Addendum No. 01

Subject: Dunbar Elementary School – Emergency Generator Replacement

SDP Contract No. B-061C of 2018/19

Location: Paul Dunbar Elementary School

E101:

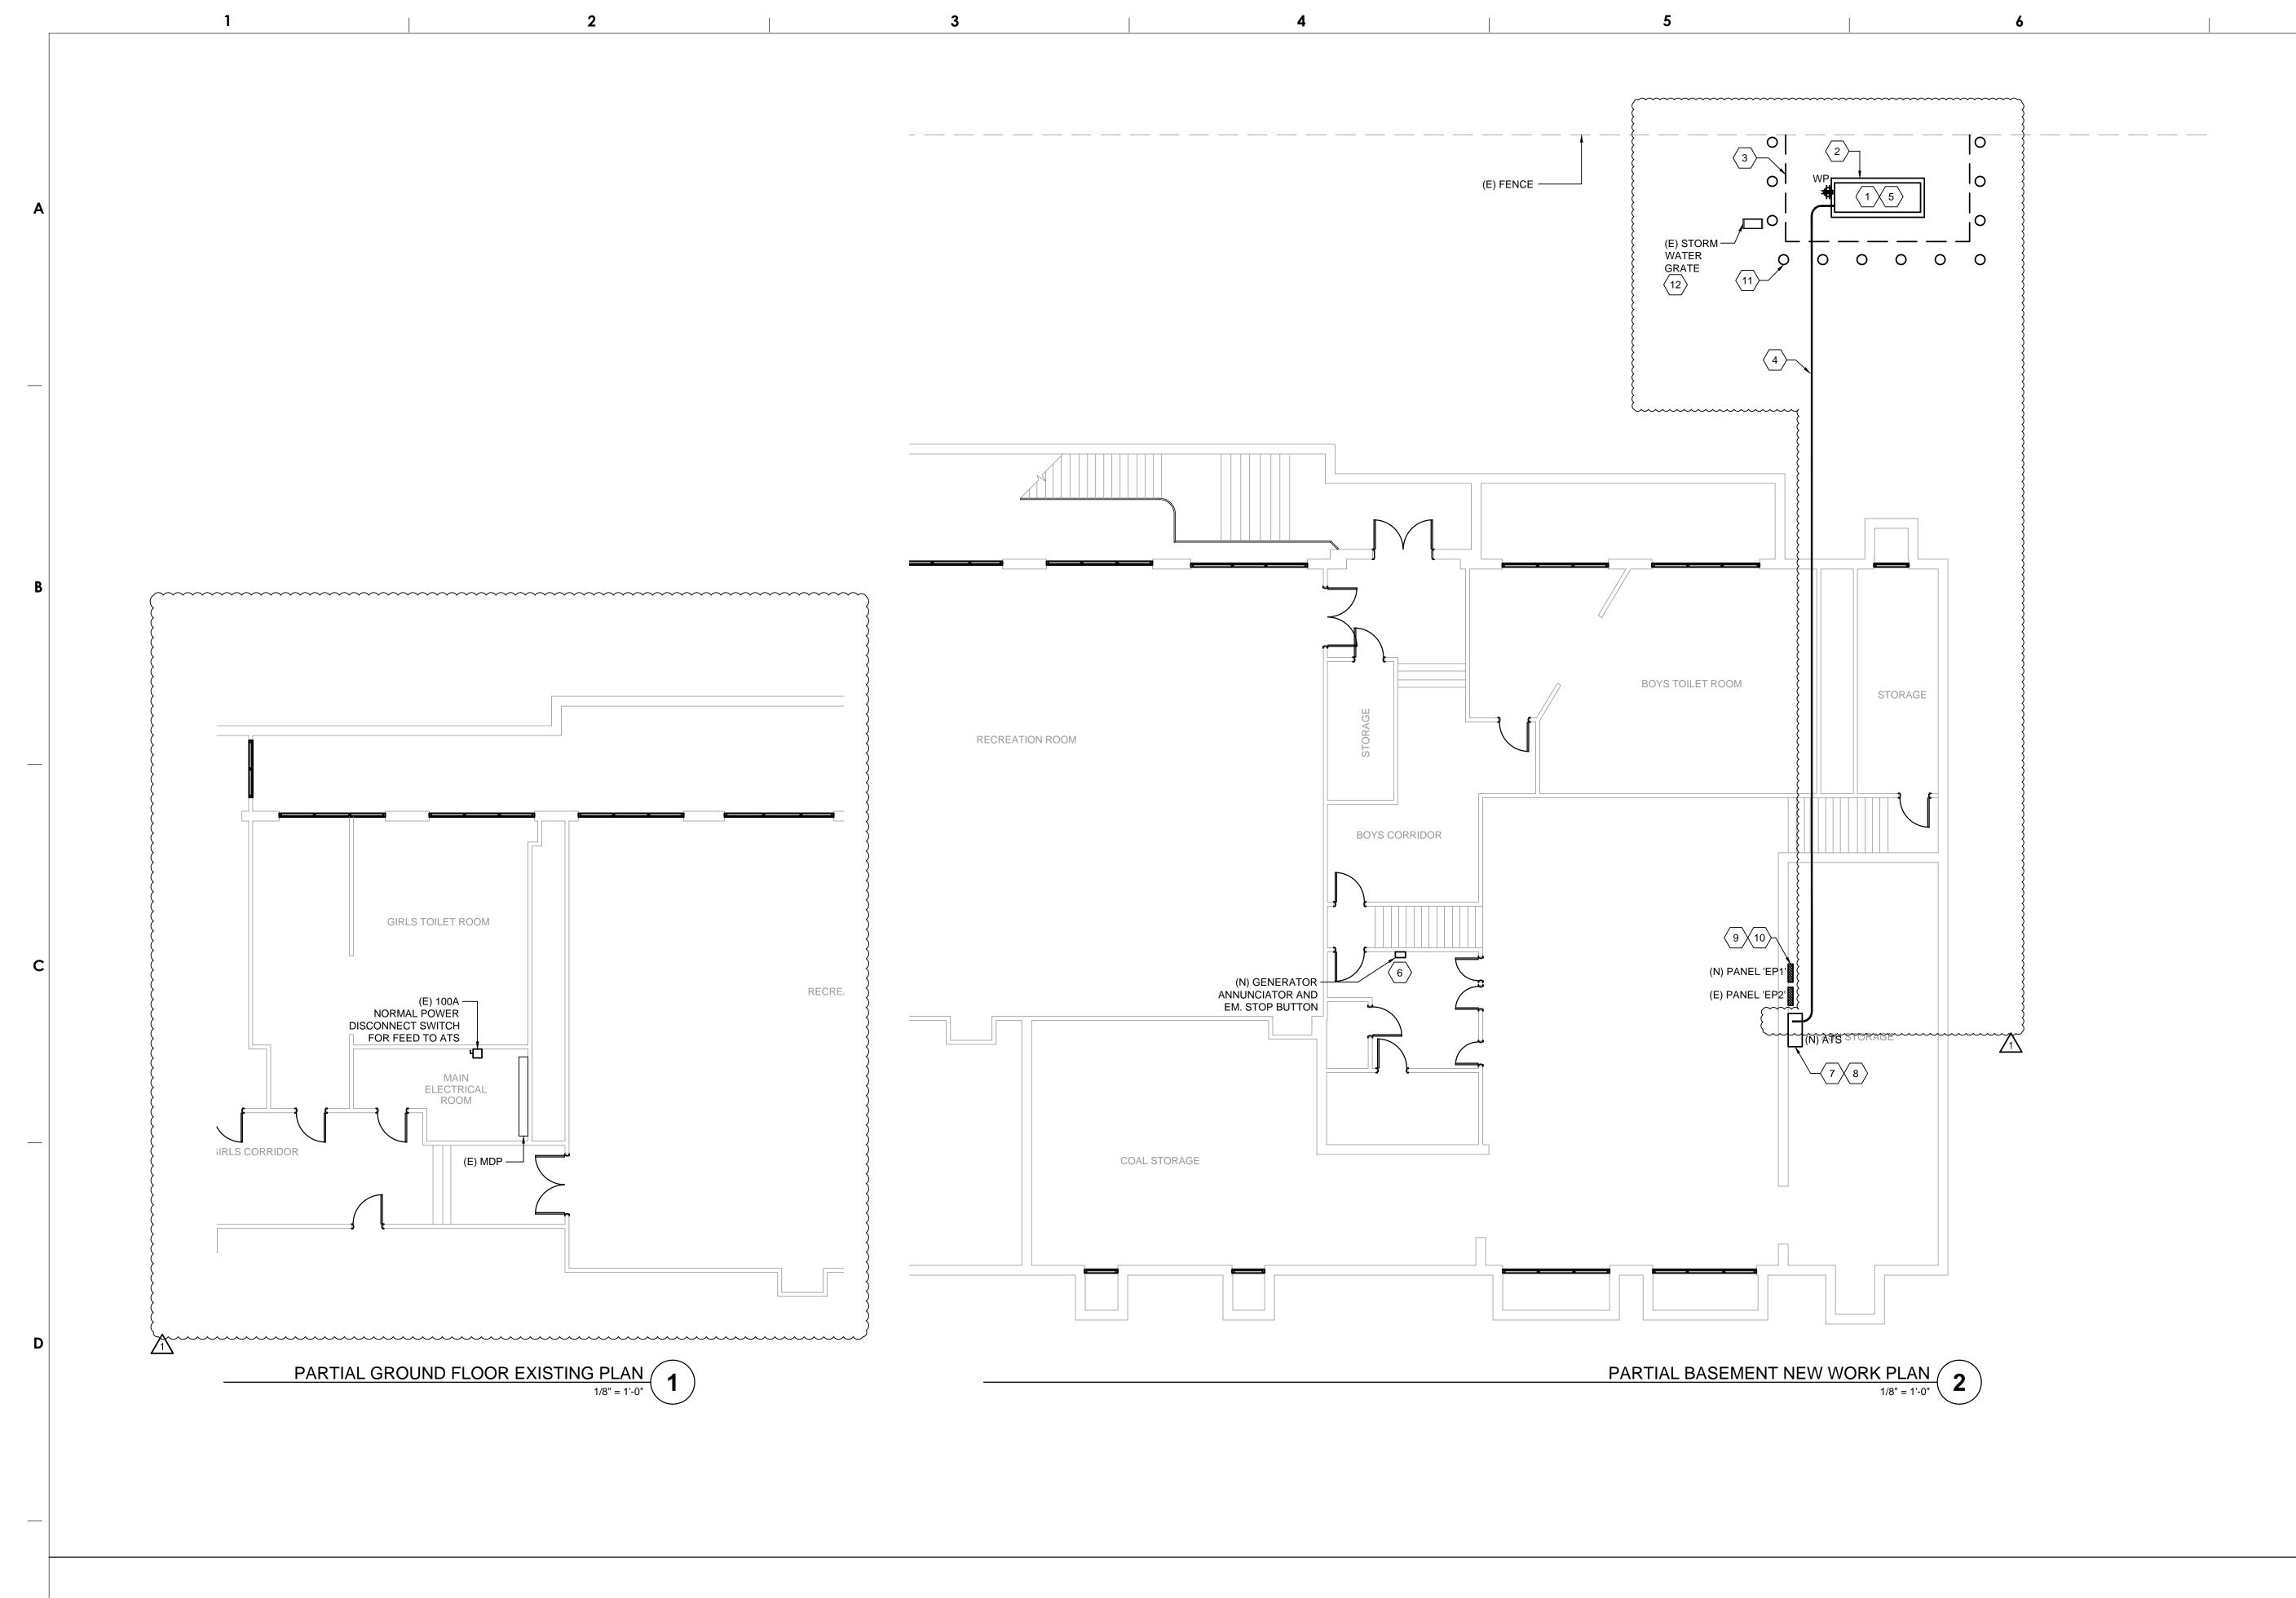
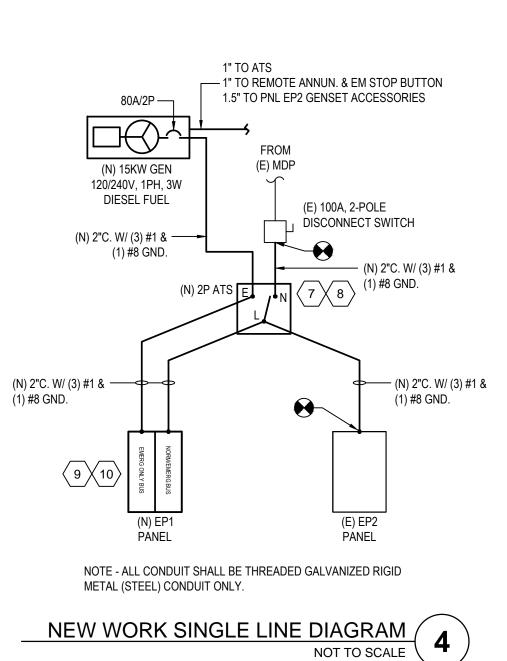
- Drawing updated to indicate location of new generator and routing of conduit.
- Drawing viewport 1 updated to clarify location of existing Normal Power disconnect switch.
- 3. New Work Key Note 4 updated to indicate routing of conduit.
- 4. New Work Key Note 11 added to indicate requirement of bollards around fence.
- New Work Key Note 12 added to indicate coordination of existing storm water grate, bollards and fencing.
- 6. New Work Key Note 7 updated to indicate new normal feeder from disconnect switch to ATS.

- 1. Question #1: Demo Drawing Note 7 states to demolish normal feed conduit and wire. Single line shows new conduit & wire for normal feed. Drawing E101.0 Note 7 states to re-use existing normal feeder.
 - a. Do we install new conduit and wire for normal feed at ATS.
 - b. Can you furnish a drawing or a distance for the conduit run if we are installing

- a. Yes. Install new conduit and wire for normal feed from disconnect switch to ATS. See revised Note 7 on drawing E101.
- b. The approximate distance of conduit run is 225 feet.

DRAWING NO. E - 501.0 SHEET 4 OF 5

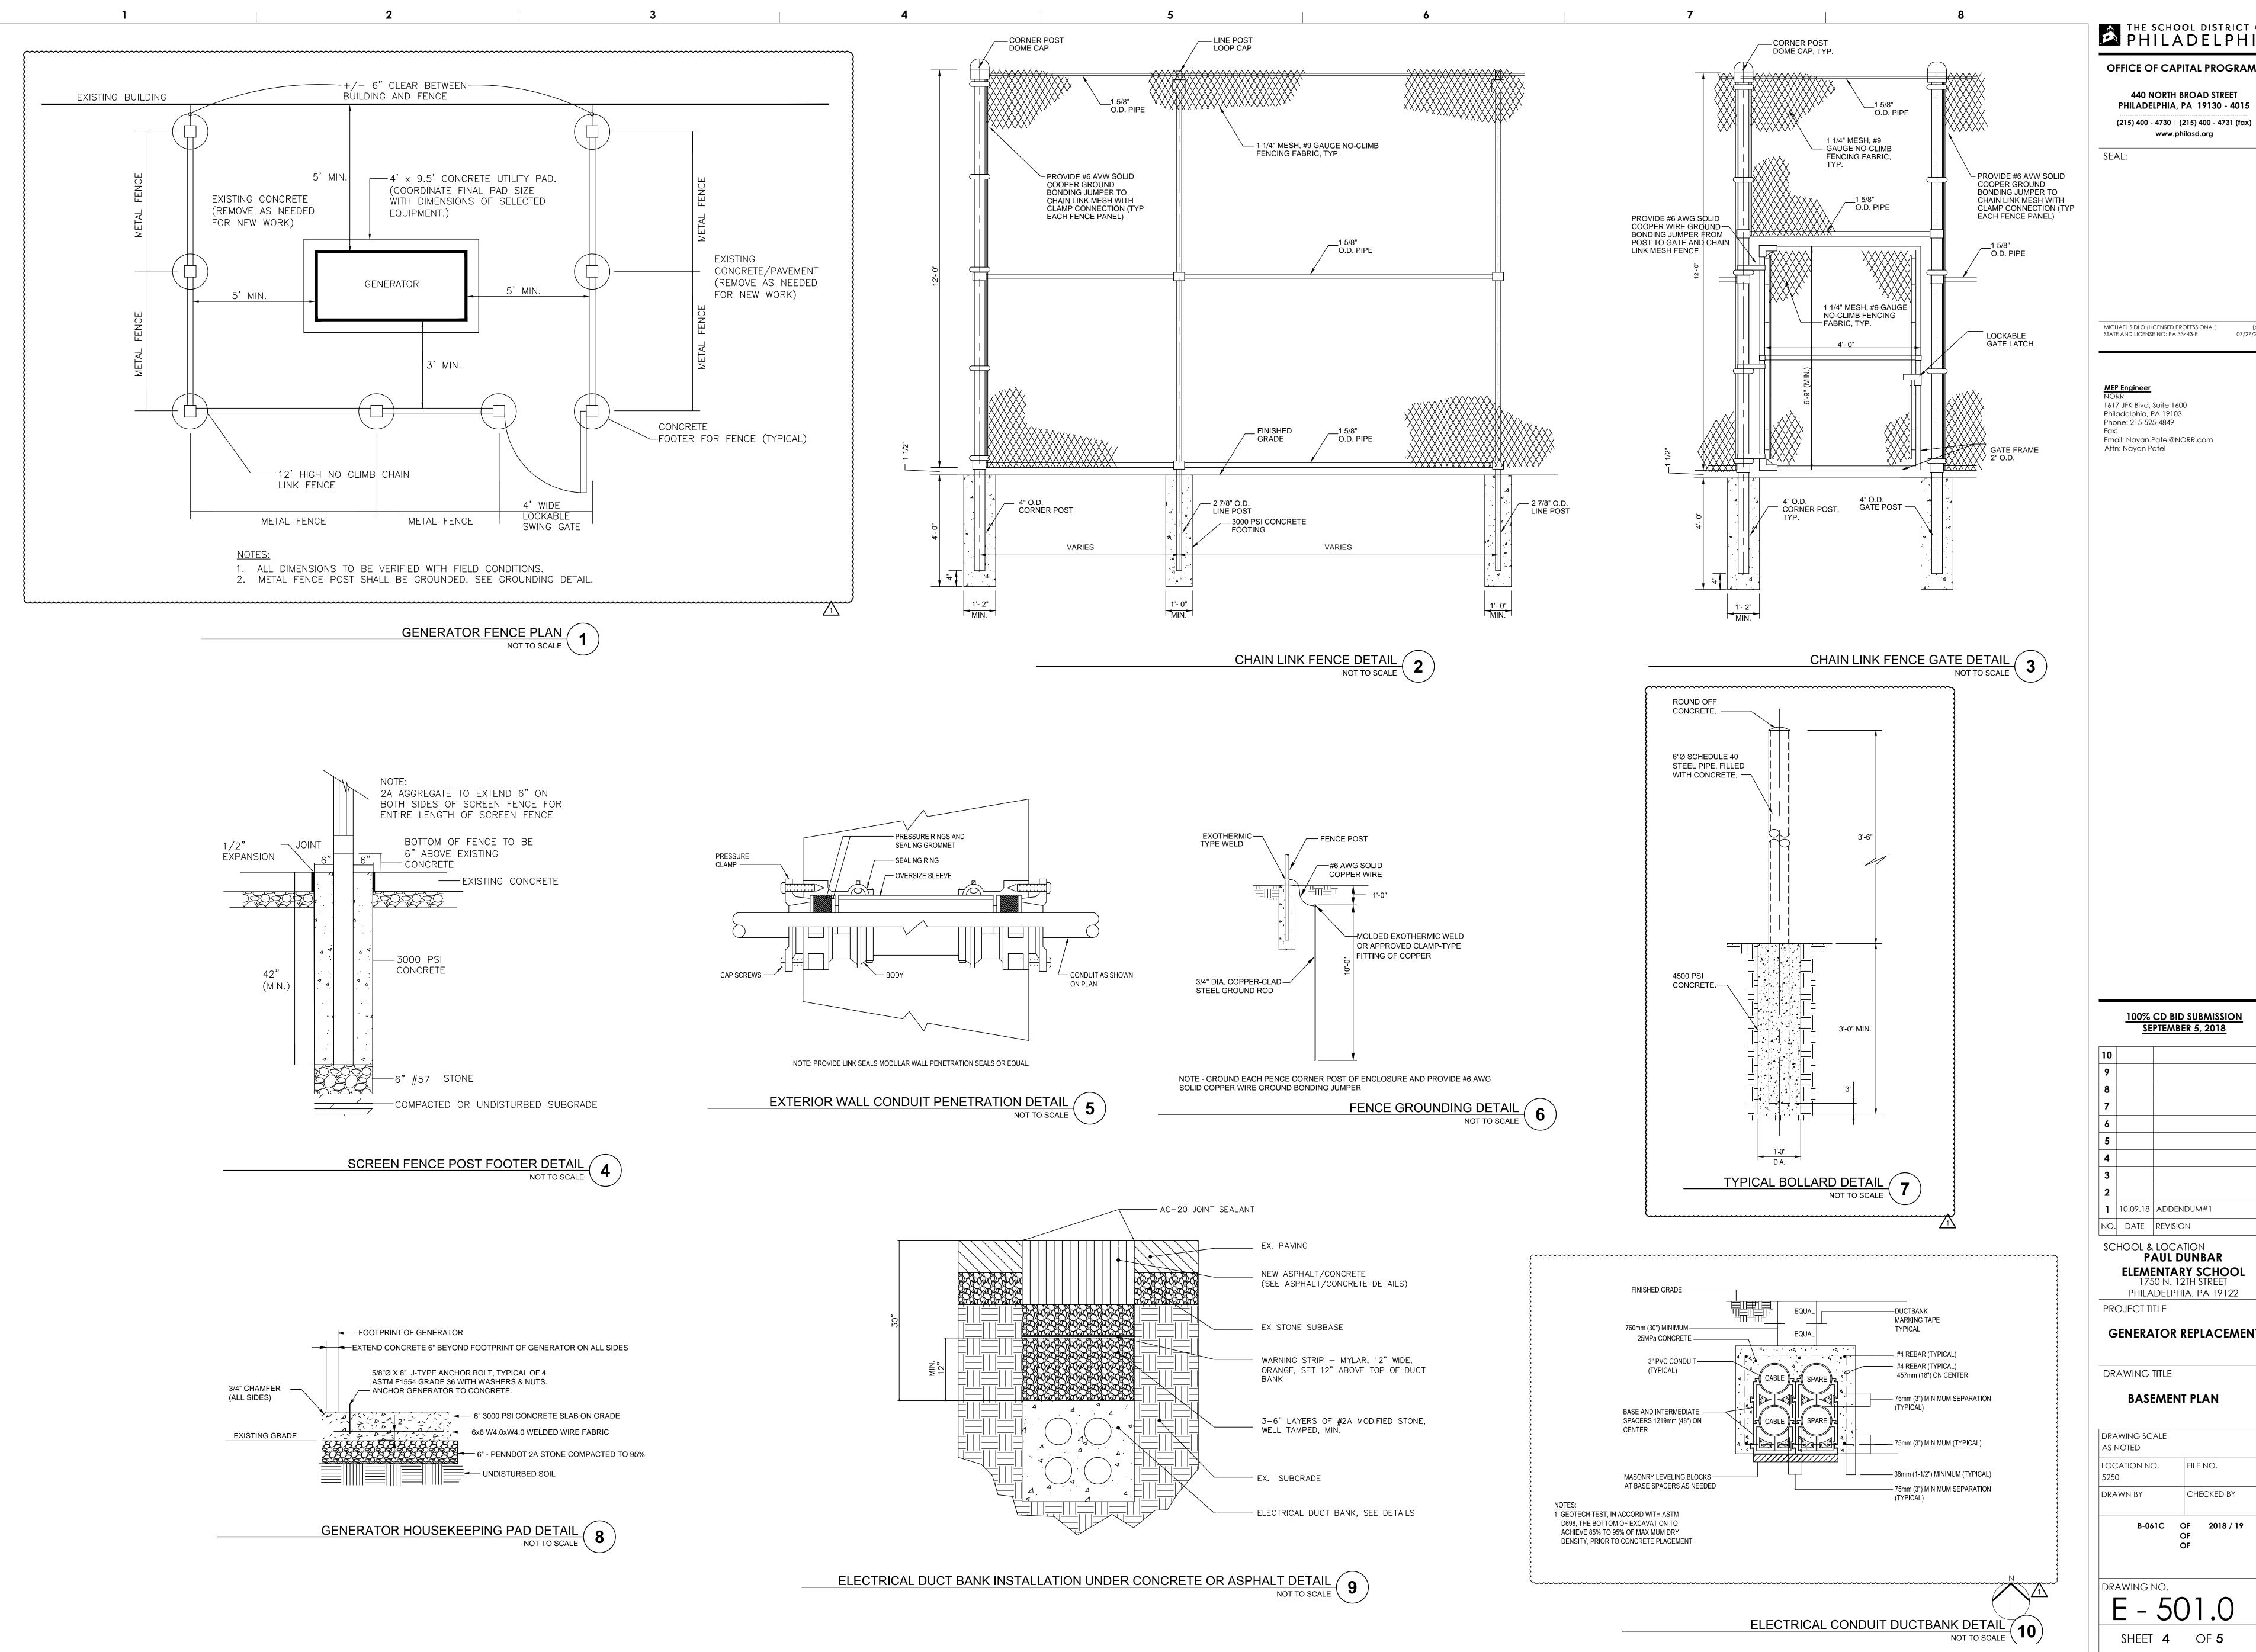
- 1. Updated Generator Fence detail (Detail#1).
- 2. Added Typical Bollard Detail (Detail#7)
- 3. Updated Electrical Conduit Ductbank Detail (Detail#10)
